**TOWN OF BLACKSTONE, MASSACHUSETTS
WATER TREATMENT PLANT
CONTRACT 2020-1, DWSRF 6686**

ADDENDUM NO. 1

E201

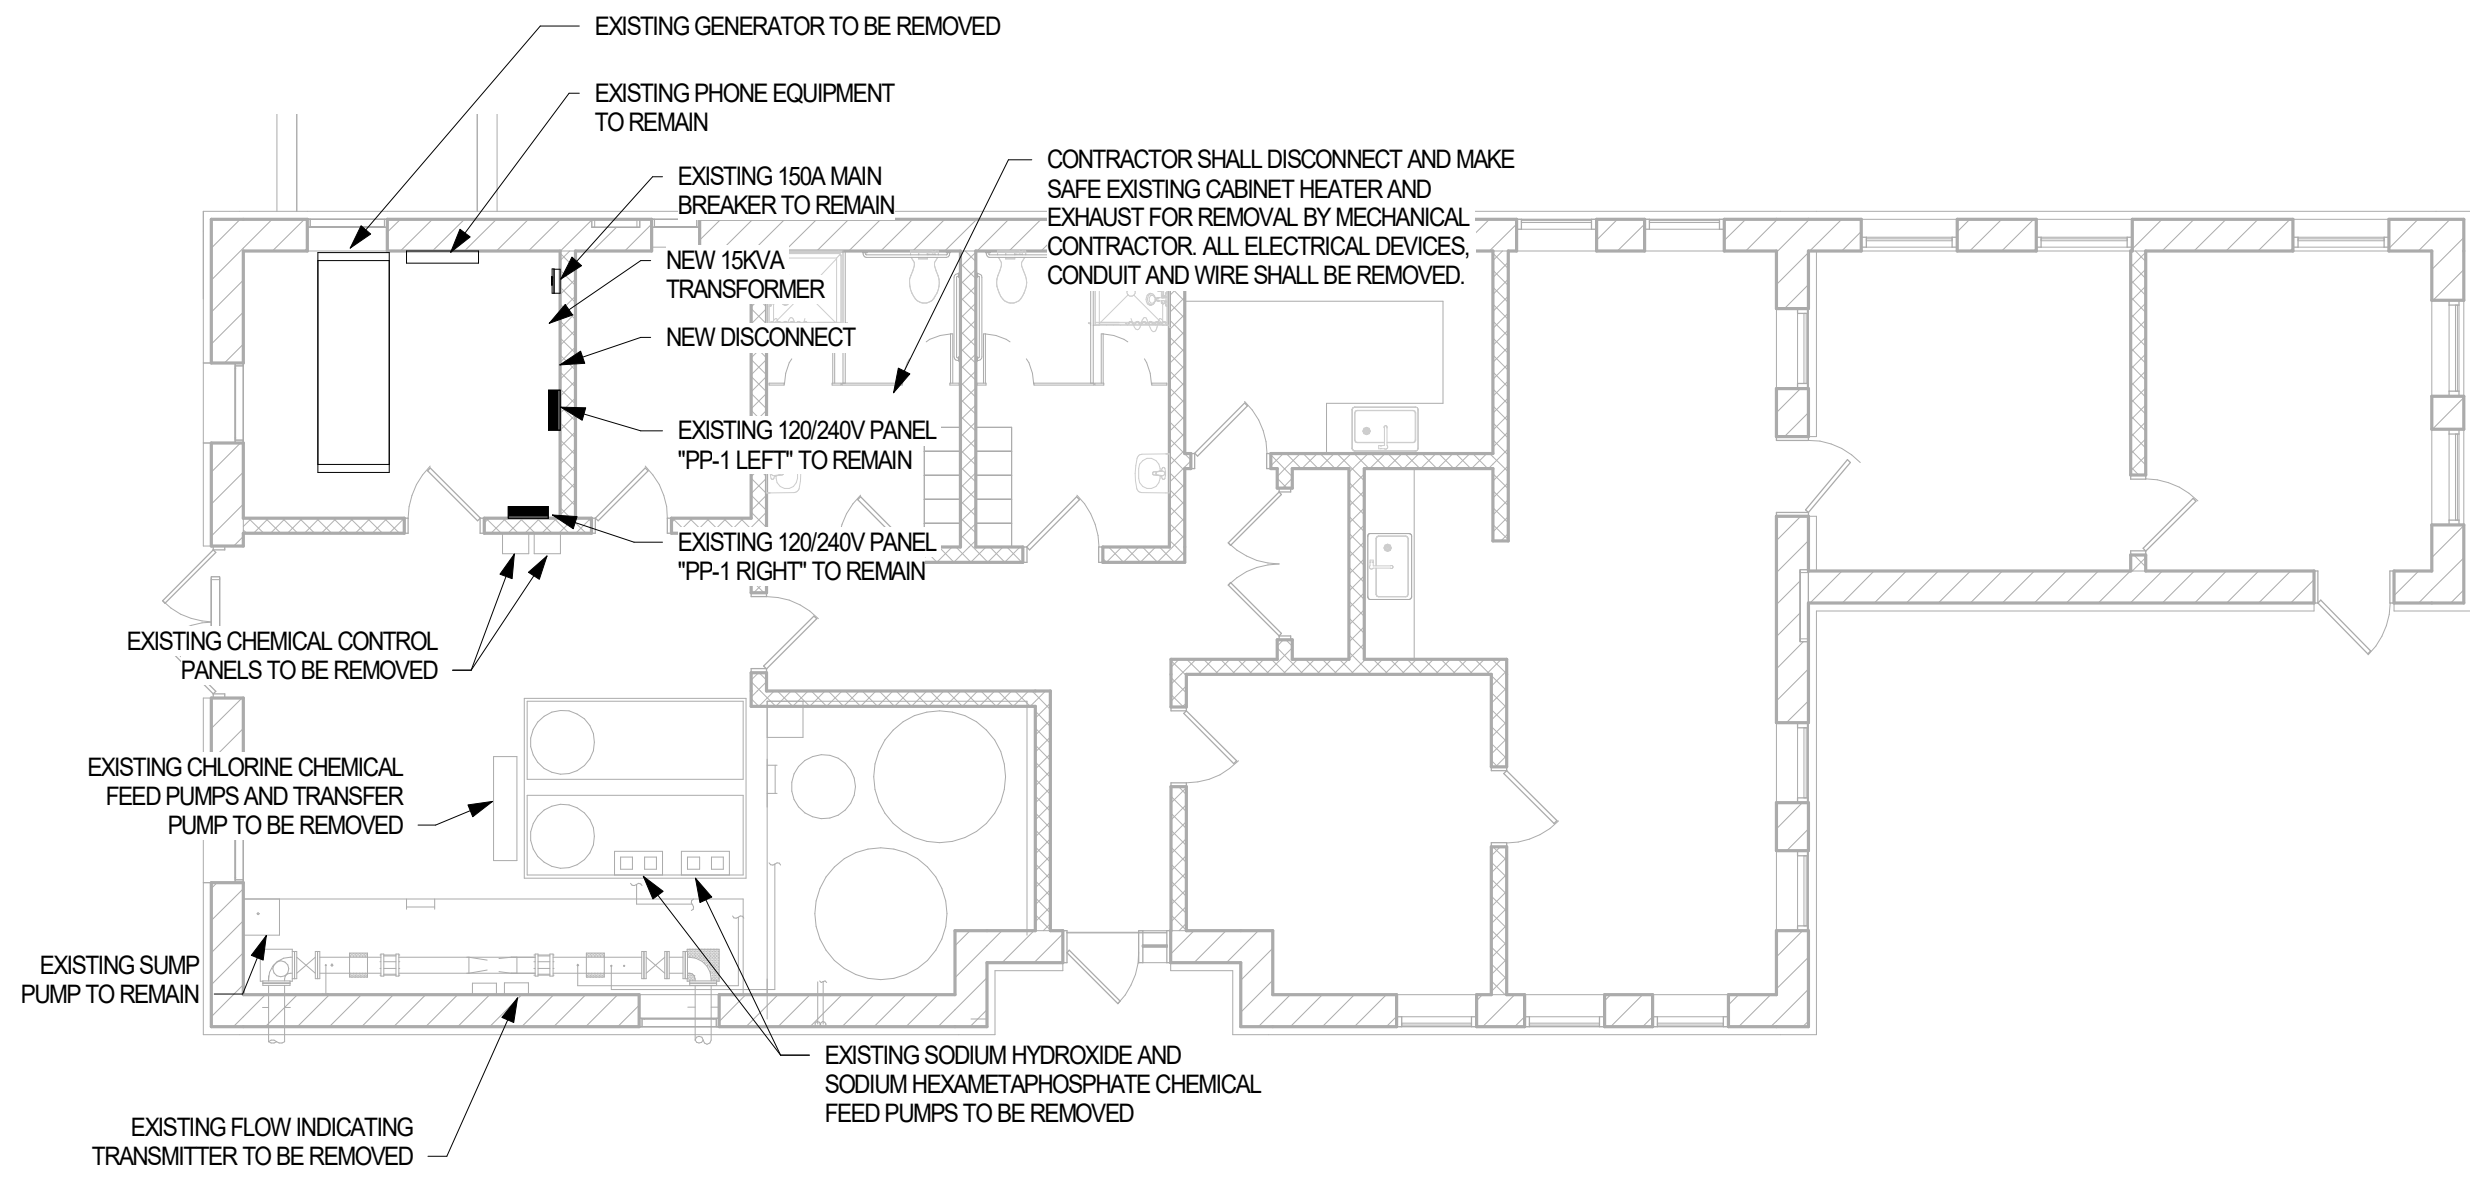
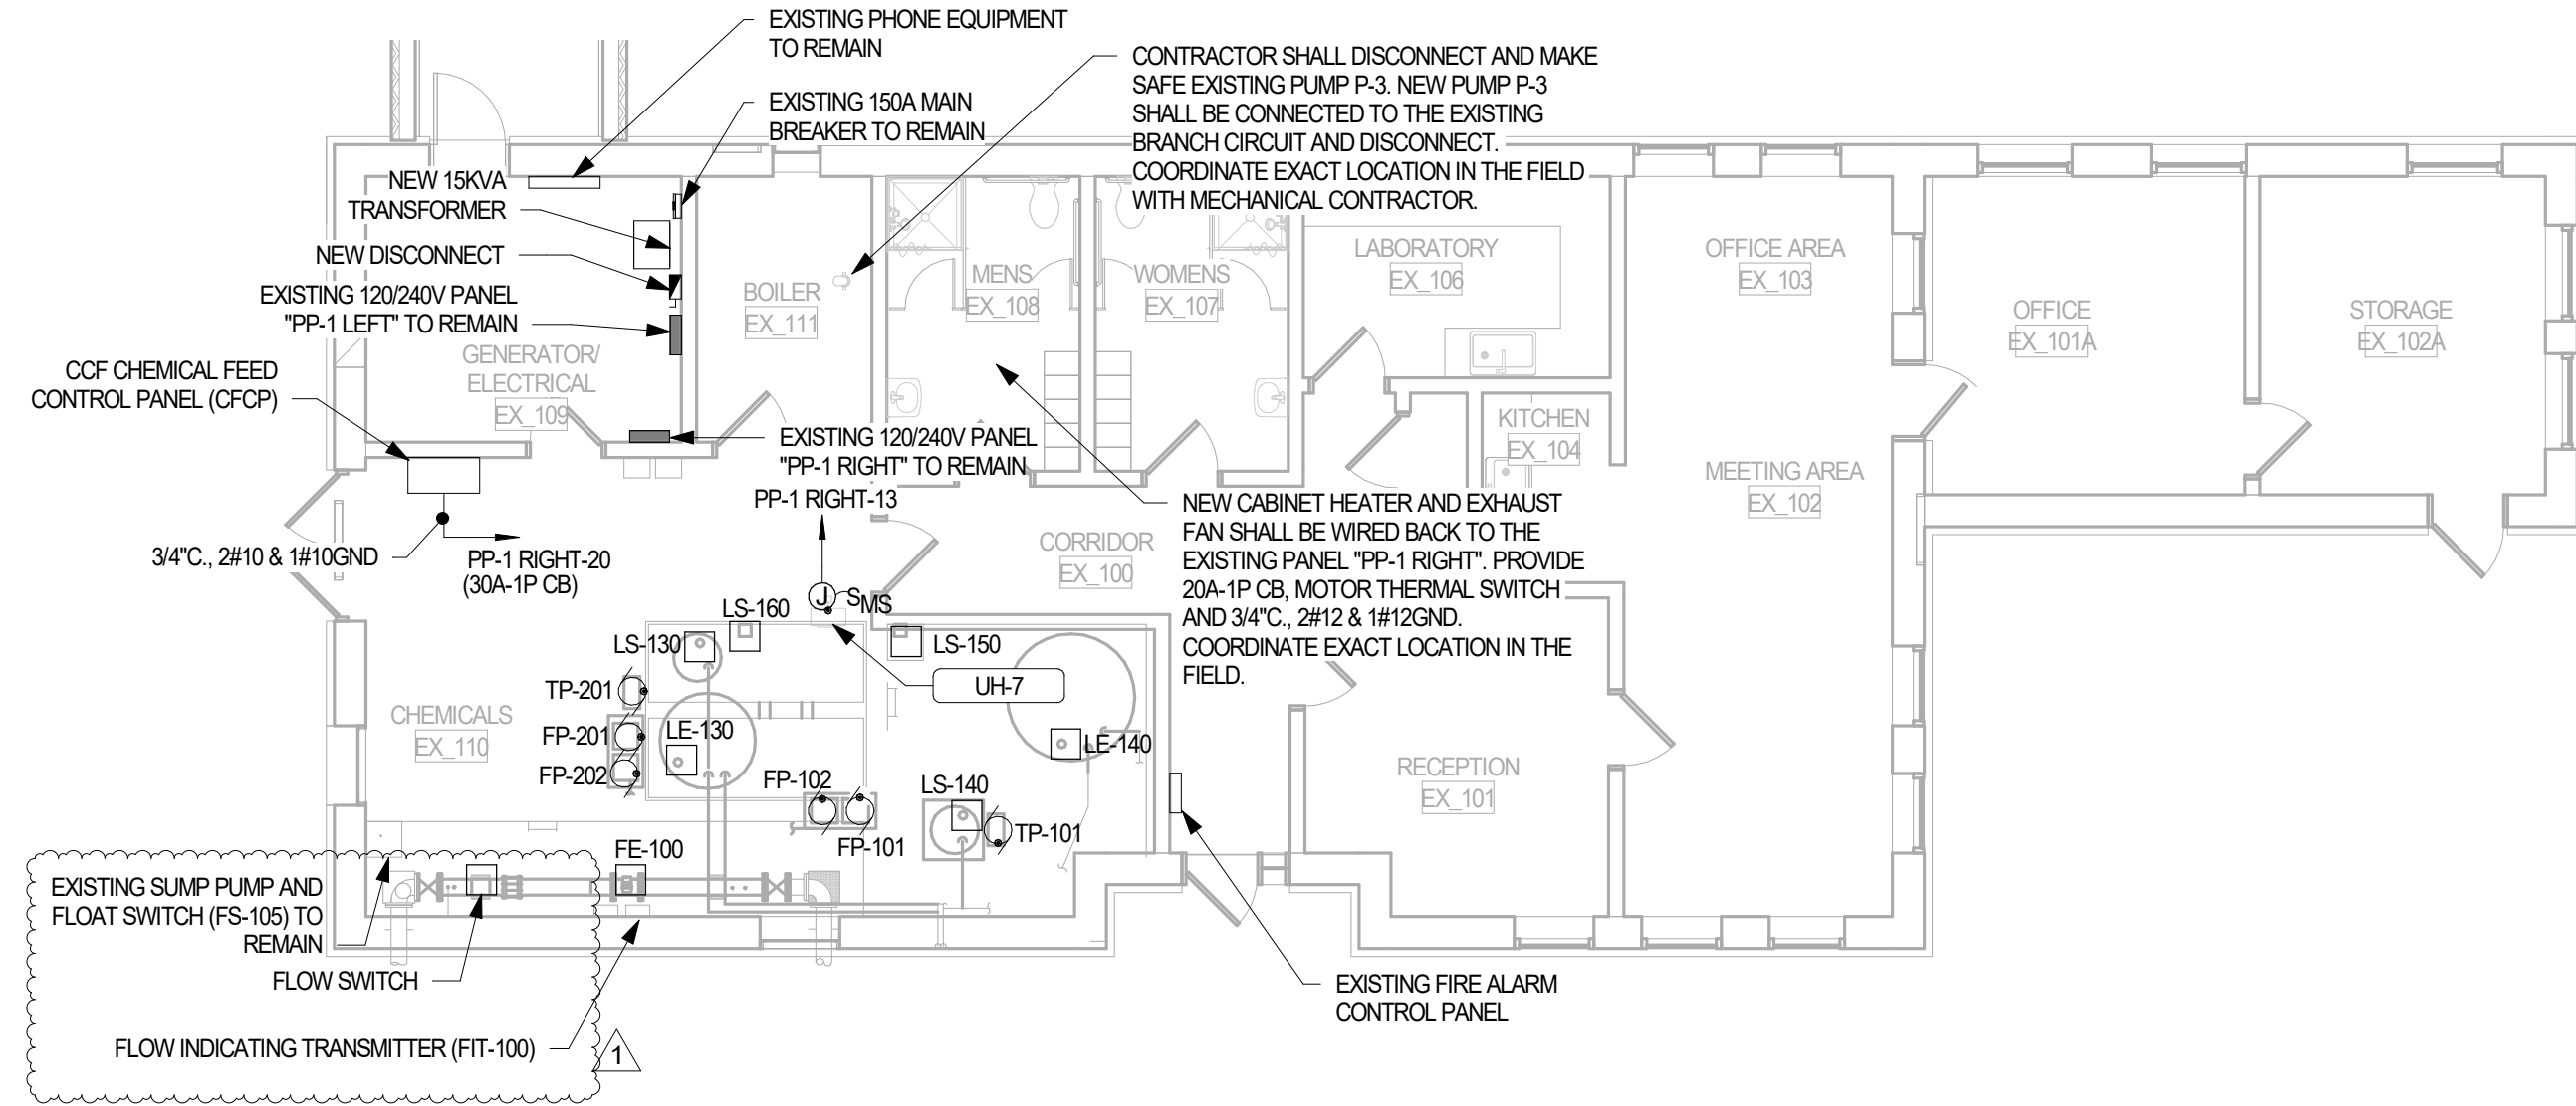
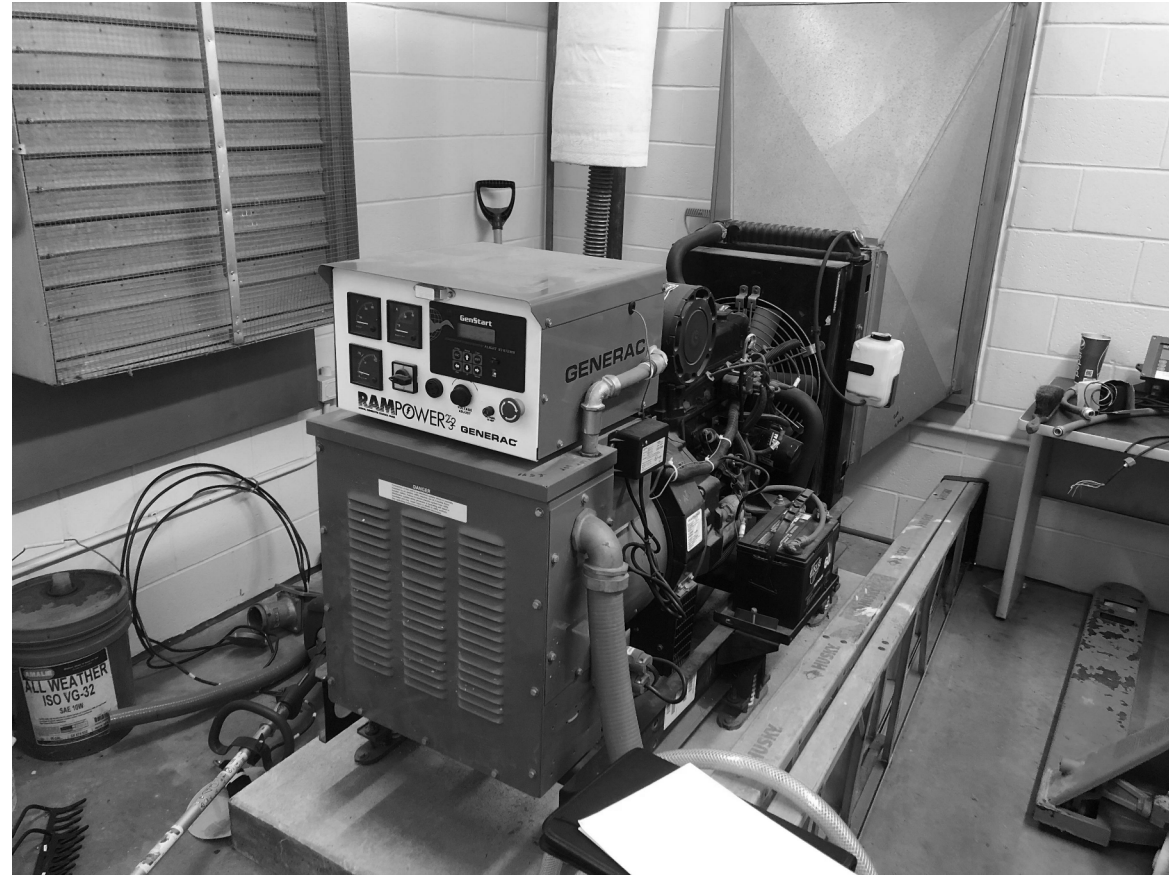
1. Delete “Sheet E201” in its entirety and replace with attached “Sheet E201 – Electrical Power Plans”.

Question: Are the HPL1-14,16,18, & 19,21,23 circuited sump pump SP-1, & -2 disconnect switches shown on drawing E201 associated with the PPL1-2 circuited SP-1, & -2 sump pump control panel?

Question: Are the Finish Water Pump FWP-110, & -120 related emergency shut/off switches shown on drawing E201 intended as stop lock-outs? If these are Finish Water Pump equipment stop lock-outs, will the 400AS/250AF fusible disconnects shown on the drawing E01 Electrical One-Line Diagram still be required? If the Finish Water Pump 400AS/250AF fusible disconnects are required, where should they be physically located?

Answer: Yes, these are the disconnects for the sump pumps. Disconnects shall be wired to sump pump controller. Refer to revised Drawings.

Answer: Yes, the disconnects shall be removed. Refer to revised drawing E601.
